**Item 4.****State Significant Development Application: 338 Pitt Street Sydney****File Nos.: SSD 10362 (D/2020/610)****D/2016/1509/A****Summary****Date of Submission:** 3 July 2020**Applicant/Developer/Owner:** China Centre Development Pty Ltd**Architect/Designer:** FJMT with Polly Harbison, Aileen Sage and Trias**Cost of Works:** \$726,854,975**Zoning:** B8 - Metropolitan Centre zone

**Proposal Summary:** The application proposes demolition, excavation and construction of two 80-storey towers and podium buildings containing 592 apartments, 158 hotel rooms, retail premises, basement car parking and servicing facilities. A publicly accessible plaza is to be provided at ground level with new through-site connections between Pitt, Liverpool and Castlereagh Streets.

**Figure 36 |** Comparison between the outline of the approved concept envelope and proposed detailed design (Source: Virtual Ideas).

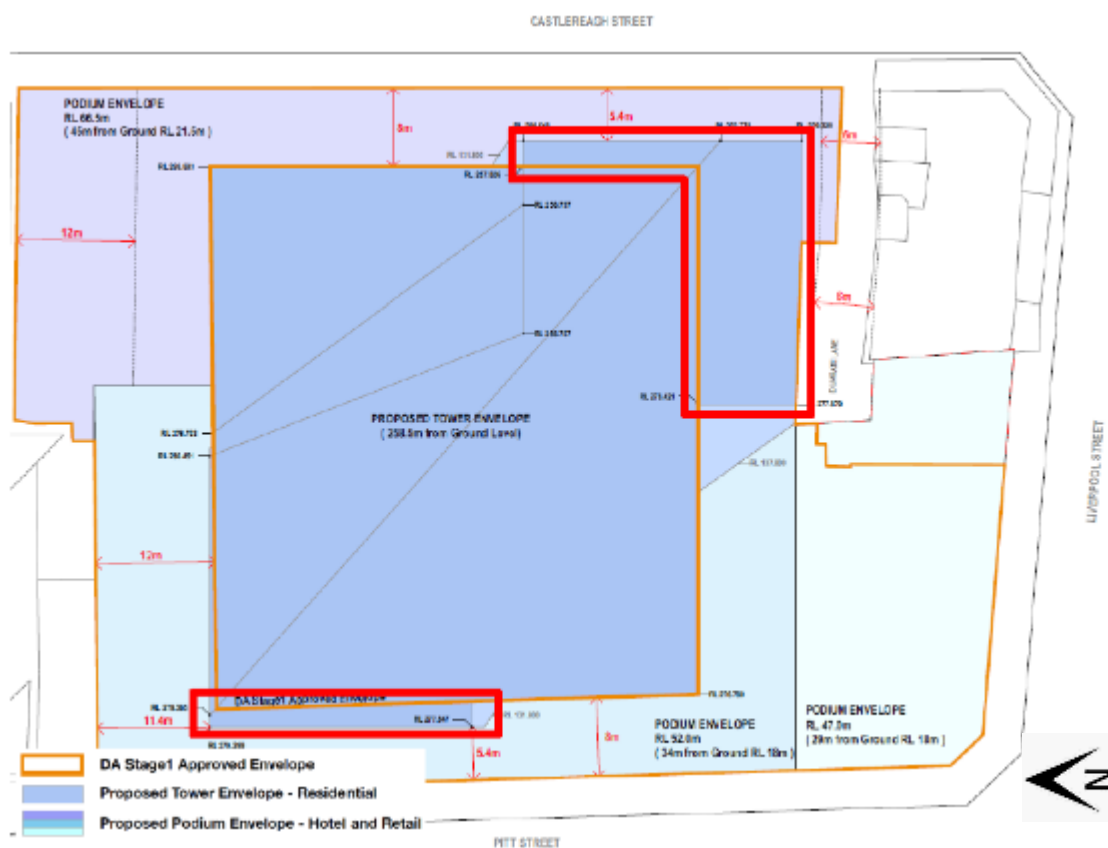
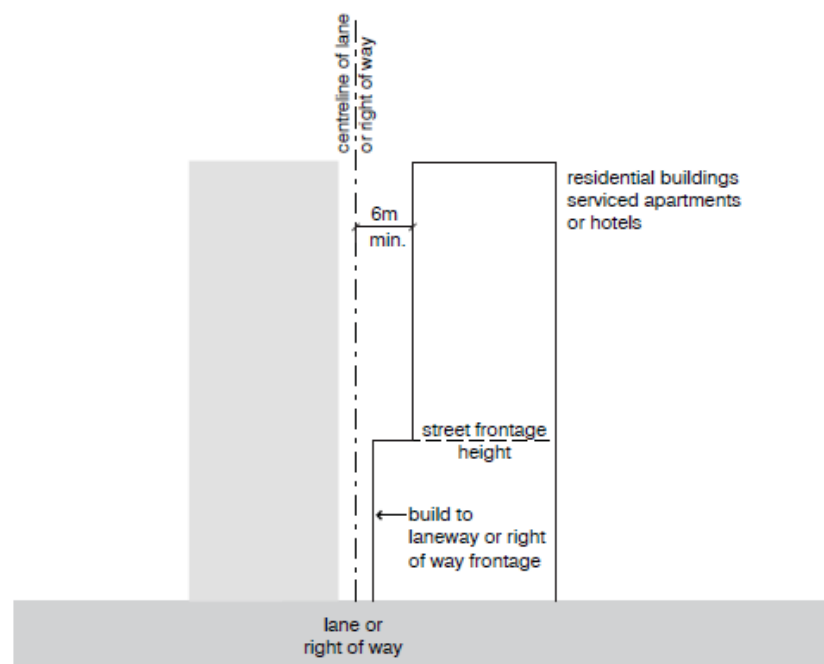
The detailed design expands the concept envelope to the northeast and southwest corners of the site to accommodate the twin tower design. This will reduce the tower setbacks to Pitt and Castlereagh Streets, in part, from 8 metres to 5.4 metres. The envelope will also extend up to the boundary of Dungate Lane and partially reduce the setback to the northern boundary from 12 metres to 11.4 metres.

The development as amended does not comply with the minimum recommended setbacks.

**Figure 52** | A heat map demonstrating the amount of direct solar access a building will receive during midwinter between 9.00am and 3.00pm, illustrating the approved building envelope at 133 Liverpool Street and the original building envelope proposed at the subject site (Source: City of Sydney).

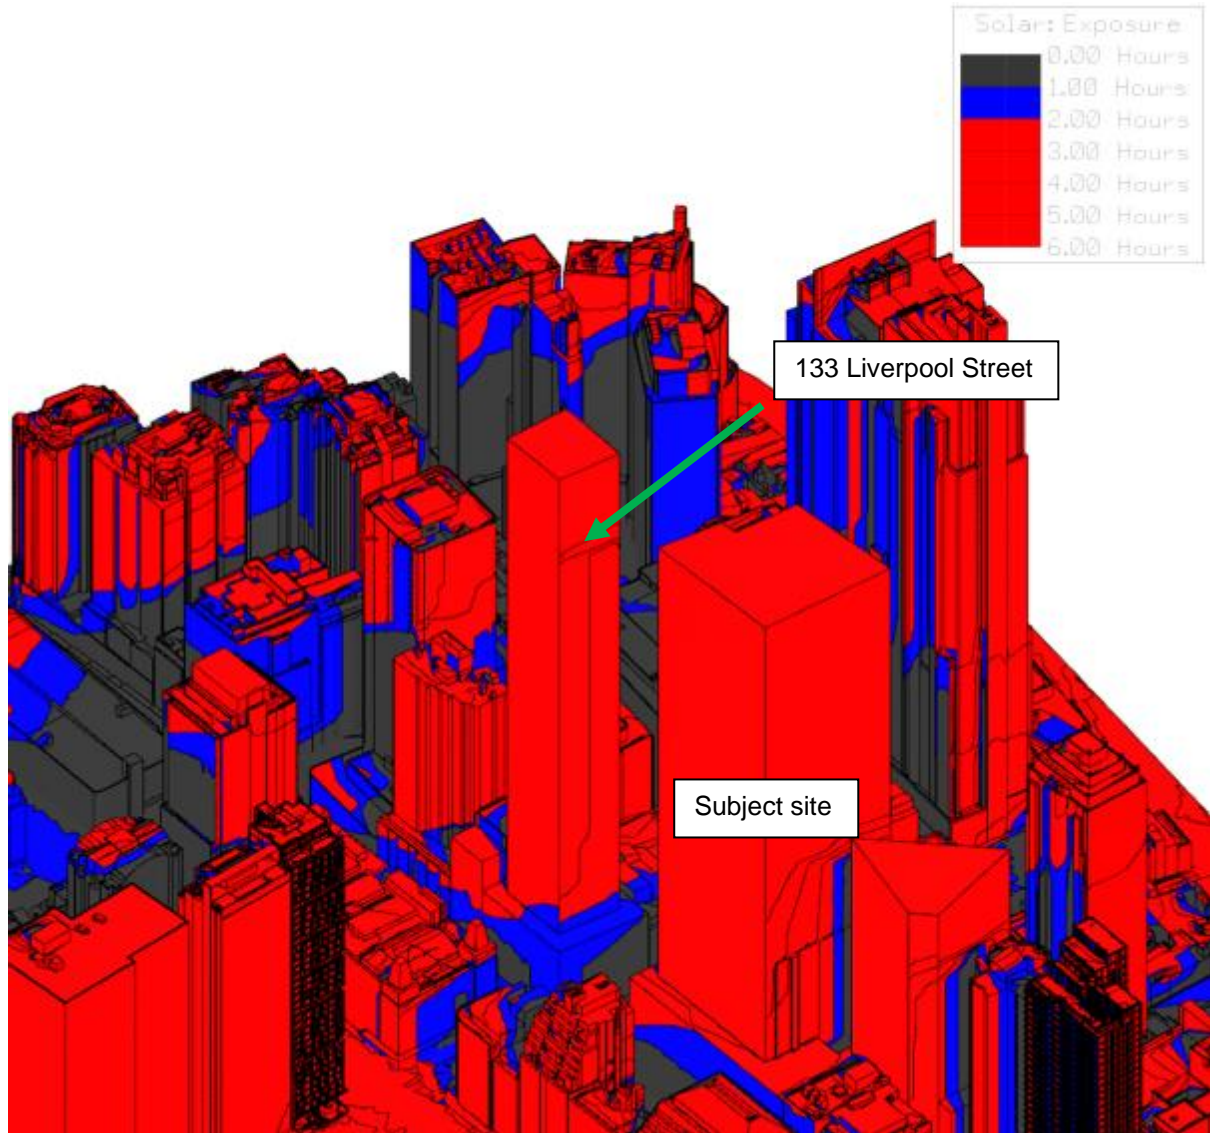
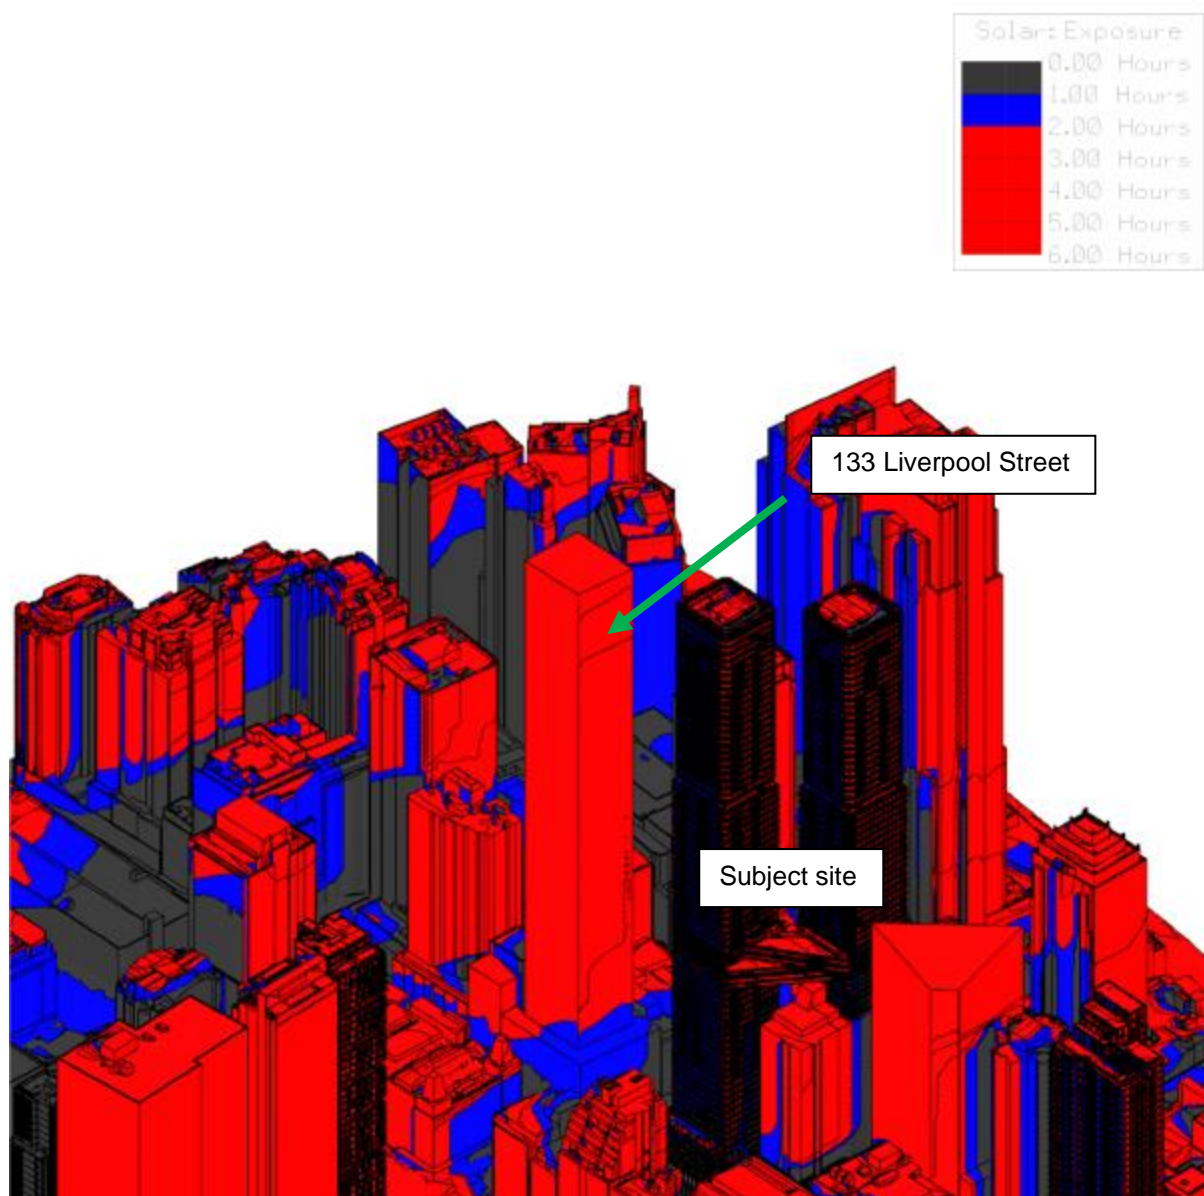
**Figures 52** and **53** below compare the amount of direct solar access received to buildings under the original building envelope proposed for the subject site, and the proposed detailed design (note that the original building envelope for the subject site illustrated in **Figure 52** was reduced in scale as illustrated in **Figure 49** above). The areas in red will receive at least two hours direct solar access midwinter between 9am and 3pm. The diagrams demonstrate that there is little to no impact to solar access caused by the detailed design application. As such, the building envelope at 133 Liverpool Street can comply with Objective 4A-1 of the Apartment Design Guide.

As previously discussed, it is recommended that the concept envelope be amended to fit the extent of the towers and skybridge to secure the benefits, and overcome the impacts, of the redistributed bulk and non-compliant setbacks, see **Figure 40** above.

**Figure 58 |** The dotted red line was the previous extent of the bridge (Source: FJMT).

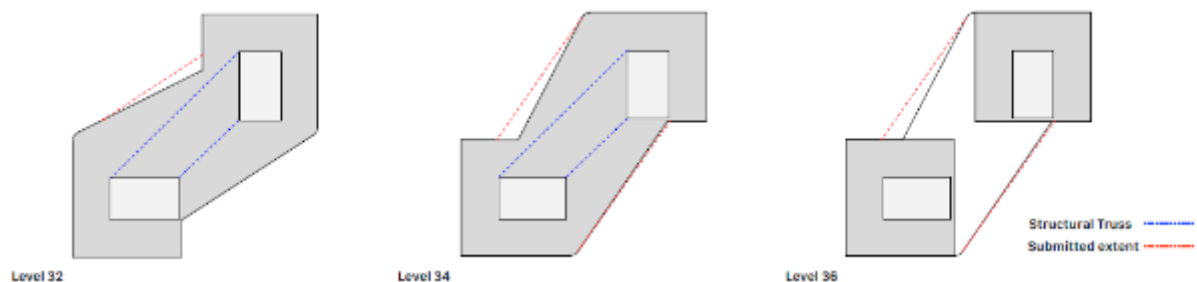
Issue	Findings	Recommendations
Refinement of the form and location of the Sky Terraces linking the two towers including the height, the detail of the interface with the tower forms, and the relationship with the location of two vertical components of the towers. This will include consideration of suitable uses for the floors in the south tower, immediately below the Sky Terraces.	<p>The applicant has provided revised plans during the assessment of the application reducing the scale of the skybridge such that it is only as wide as is recommended by the structural engineer to support the towers.</p> <p>The skybridge serves to segment the lower third of the towers, with an additional landscaped recess provided to the segment the middle and upper thirds, providing a rational design response.</p>	The matter, as raised by the competitive design panel and Design Advisory Panel, has not been resolved to the satisfaction of the City. As such, a deferred commencement condition is recommended requiring the skybridge to be further reduced in size.

The floors directly beneath the skybridge are dedicated to plant. The apartments below the plant rooms will have reasonable amenity and, as demonstrated in **Appendix B**, the development achieves a good standard of amenity as a whole.

**Figure 65 |** The corner apartments are recommended to be used as either an extension of the communal open space or as common areas for residents due to poor visual privacy from the skybridge (Source: FJMT).

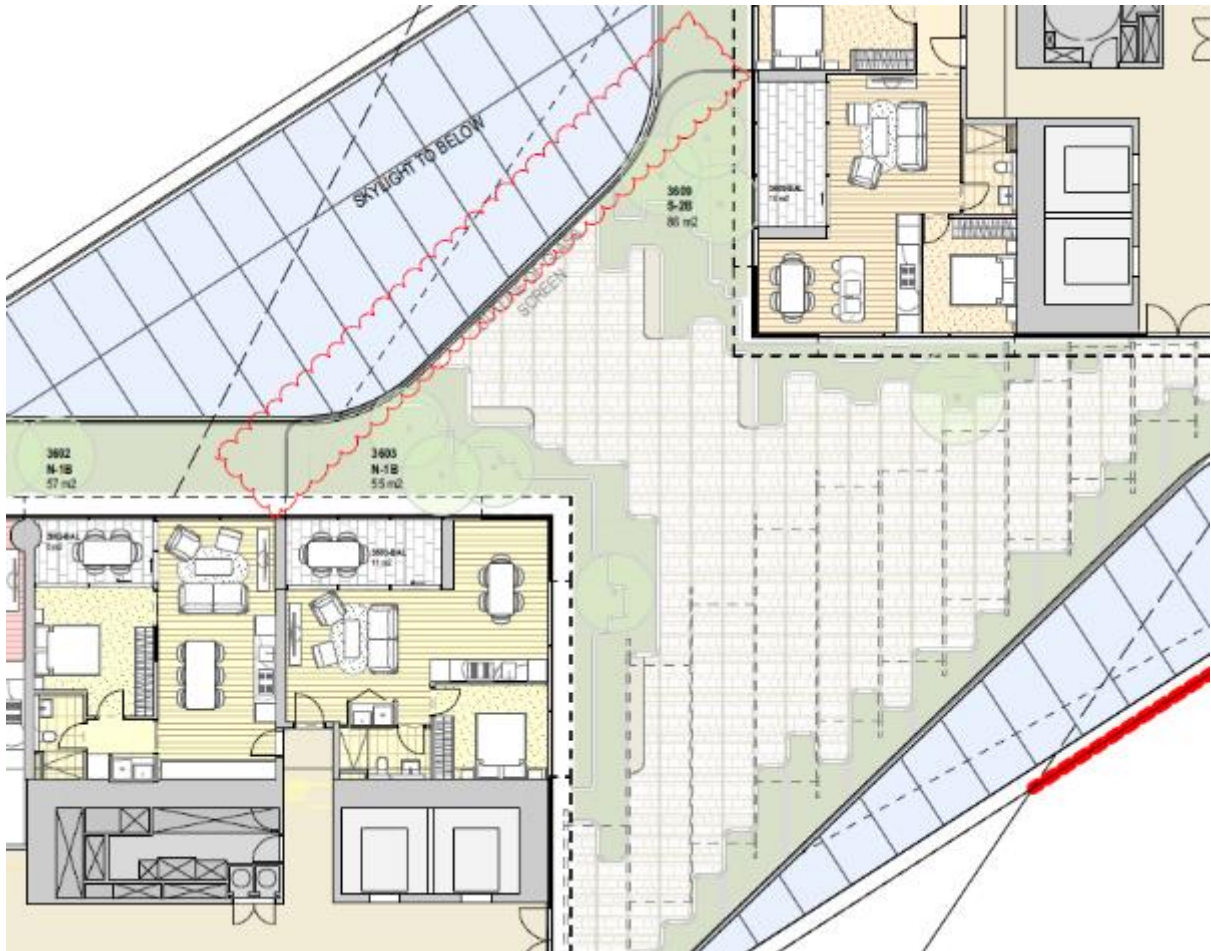
Issue	Findings	Recommendations
<b>Visual privacy</b>	<p>Objective 3F-2 of the ADG states that communal open space, common areas and access paths should be separated from private open space and windows to apartments, particularly habitable room windows. As shown in the Figure below, the open space of the skybridge directly adjoins habitable room windows of apartments.</p> <p>The applicant proposes a vegetative screen to provide visual separation between the skybridge and habitable</p>	<p>A condition is recommended requiring apartments 3603 and 3609 to be converted to communal rooms or a partially enclosed extension of the common open space.</p>

rooms of the apartments, however this is inadequate given the proximity of the open space and wind impacts on vegetation. Converting two of 592 apartments to greater common facilities/open space is not unreasonable.

**Figure 66 |** A diagram illustrating the architectural device within the windows to deflect views (Source: FJMT).

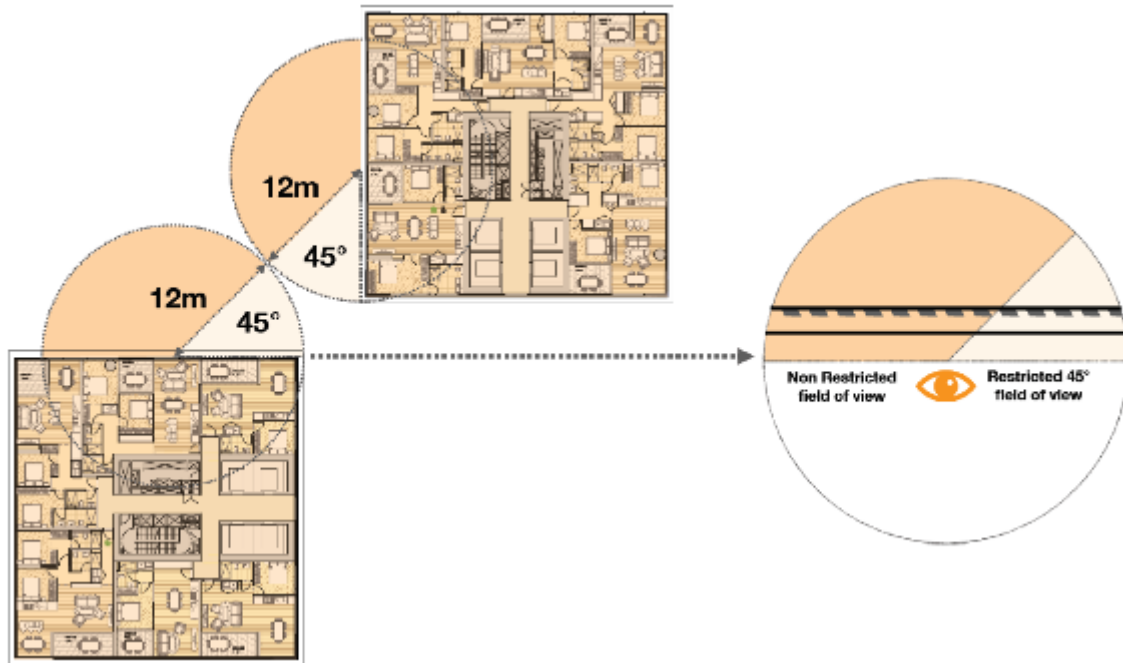
overlooking. **Figure 66** below illustrates how this will operate.

**Figure 68** | East-west section towards Liverpool Street, illustrating the location of the basement and footings over the north bound Sydney Metro tunnel (Source: Arup)

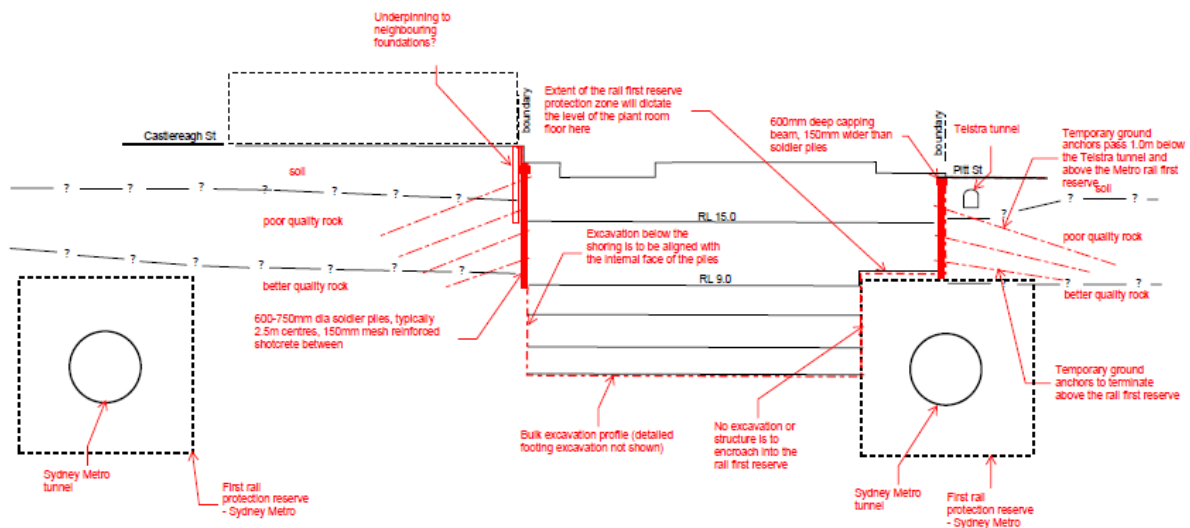
The application is adjacent to the Sydney Metro rail corridor and was subsequently referred to Sydney Metro for comment. **Figures 69 and 70** below identify the location of the tunnels relative to the proposed development.

Additional information was requested, to which the applicant responded within the Response to Submissions. Sydney Metro is not satisfied that sufficient information has been provided to protect the structural integrity of the Sydney Metro tunnel as a result of the proposal.
